MSD Crab Cap, PN 8541 For Distributors, PN 8486, PN 8489

FRM28659 Revised 05/07 Printed in U.S.A.

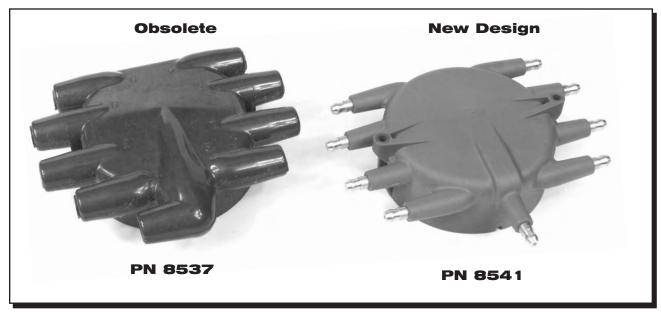
This Cap is an updated replacement for the PN 8537 Cap which is now obsolete. The new design is injection molded from Dupont Rynite material which is stronger physically and holds higher dielectric strength.

This Cap also incorporates spark plug style terminals for an improved connection to the plug wire terminals. This change necessitates different terminals and boots for the spark plug wires. A set of nine short 90° boots and terminals is available as PN 8848.

This Cap has the hold-down retaining bosses molded in and simply screws down to the distributor base using the same socket head cap screws. The original rotor, PN 8567, and rotor base, PN 8568, are still used.
